**ARCHITECTURAL REVIEW BOARD STAFF REPORT**

<b>Project #/Name</b>	<b>ARB-2024-24: Flow Honda Final</b>
<b>Review Type</b>	Review of a final design
<b>Parcel Identification</b>	04500-00-00-068D4
<b>Location</b>	960-A Hilton Heights Road, on the west side of Routh 29 North, at the intersection of Hilton Heights Road and Route 29. (Fig. 1)
<b>Zoned</b>	Highway Commercial (HC), Entrance Corridor (EC)
<b>Owner/Applicant</b>	Flow 960 Hilton LLC / Design Develop LLC (Kevin Schafer)
<b>Magisterial District</b>	Rio
<b>Proposal</b>	The applicant proposes to renovate the Flow Honda showroom building by removing the existing entrance tower and canopy, adding a layered frame around new storefront windows, and adding a new canopy over the service vehicle entrance.
<b>Context</b>	The Flow Honda site is located in the heavily developed Rt. 29 commercial corridor. The Honda building is located just north of the Flow Subaru (previously Umansky) building. The showroom and service for Honda is part of a larger building that also houses the Chrysler, Dodge, Jeep, Ram showroom. A Walmart is located to the south across Hilton Heights Rd. Just beyond Walmart is the Malloy (previously Price) Chevrolet aut

Figure 4: SDP2003-67 Approved Landscape Plan (Phase I)

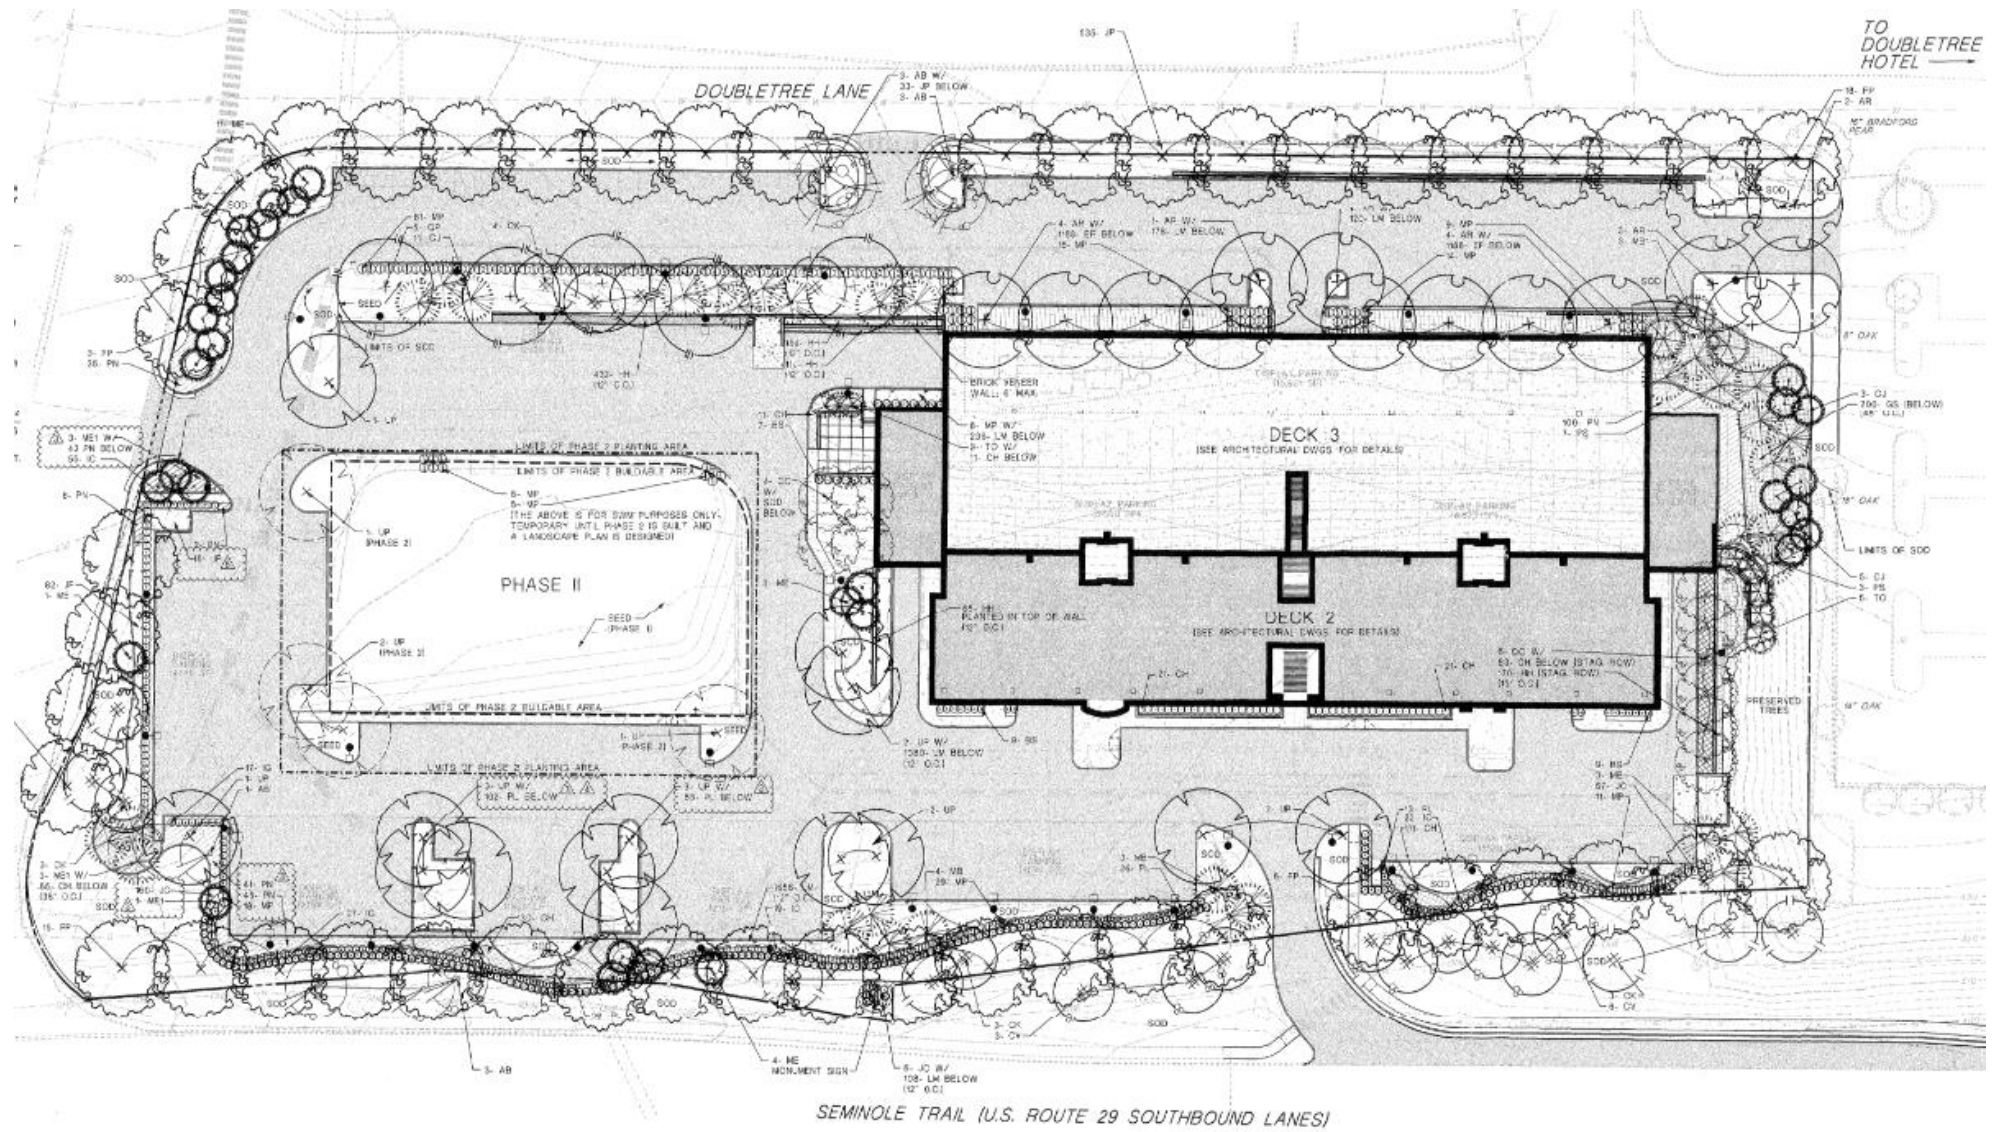
7-8, 32-38	<b>Landscaping</b>	No changes are proposed to the existing landscaping, but some of the approved landscaping along Rt. 29 is missing (Fig. 4).	On-site landscaping must comply with the approved site plan.	The submittal includes information on landscaping missing from the site. However,	Confirm and replace all landscaping missing

The approved landscaping successfully mitigated the parking and integrated the development into the Entrance Corridor. Maintaining the approved landscaping is important to maintaining orderly, harmonious, and attractive development along the corridor.		the information provided only confirms landscaping missing from the Honda/CDJR portion of the site. Landscaping is also missing from the Subaru portion of the site. Bringing the entire site into conformity would provide a consistent appearance along the corridor.	from the approved site plan.
	<b>Site Development and layout</b>				
	<b>Development pattern</b>				
39	<p>The relationship of buildings and other structures to the Entrance Corridor street and to other development within the corridor should be as follows:</p> <p>a. An organized pattern of roads, service lanes, bike paths, and pedestrian walks should guide the layout of the site.</p> <p>b. In general, buildings fronting the Entrance Corridor street should be parallel to the street. Building groupings should be arranged to parallel the Entrance Corridor street.</p> <p>c. Provisions should be made for connections to adjacent pedestrian and vehicular circulation systems.</p> <p>d. Open spaces should be tied into surrounding areas to provide continuity within the Entrance Corridor.</p> <p>e. If significant natural features exist on the site (including creek valleys, steep slopes, significant trees or rock outcroppings), to the extent practical, then such natural features should be reflected in the site layout. If the provisions of Section 32.5.2.n of the <i>Albemarle County Zoning Ordinance</i> apply, then improvements required by that section should be located so as to maximize the use of existing features in screening such improvements from Entrance Corridor streets.</p> <p>f. The placement of structures on the site should respect existing views and vistas on and around the site.</p>	<p>No changes are being made to the existing access to the site. The existing building is to remain parallel to the EC and no alterations to the existing on-site circulation patterns are proposed.</p> <p>The site has been previously developed. Views around the site are not expected to be negatively impacted.</p> <p>No changes to the site have been provided with this submittal. The applicant's narrative notes that information on landscaping and exterior site lighting will be provided with subsequent submissions.</p>	See the recommendations provided with the lighting and landscaping Guidelines above.	<p>No changes are being made to the existing access to the site. The existing building is to remain parallel to the EC and no alterations to the existing on-site circulation patterns are proposed.</p> <p>The site has been previously developed. Views around the site are not expected to be negatively impacted.</p>	See the recommendations provided with the lighting and landscaping Guidelines above.

4. Confirm and replace all landscaping missing from the approved site plan.
5. Sign applications are required for all proposed signs. New signs will be reviewed for compatibility with existing signs. Information on the illumination value, fixture finish, and color temperature for the spotlight will be needed if proposed.
